UPPER TRUNNION BLOCK KIT

BEAU-ROC WILL SOON BE REPLACING THE UPPER TRUNNION BLOCK KIT WITH AN IMPROVED DESIGN

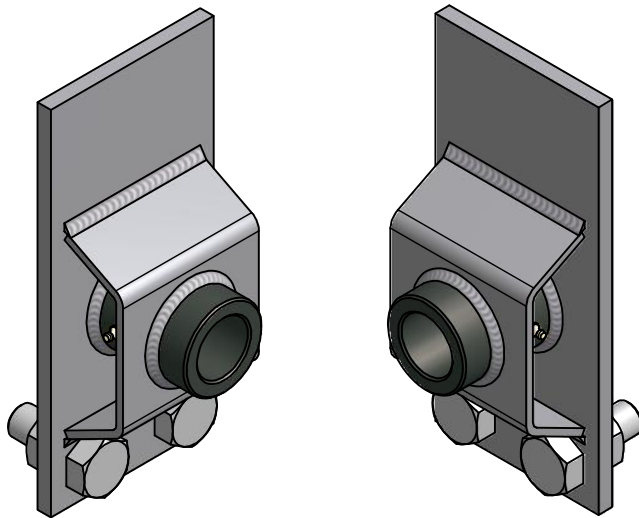
- Each trunnion block is now equipped with grease fittings on both sides
- Side plates have been removed to facilitate the access to the grease fittings
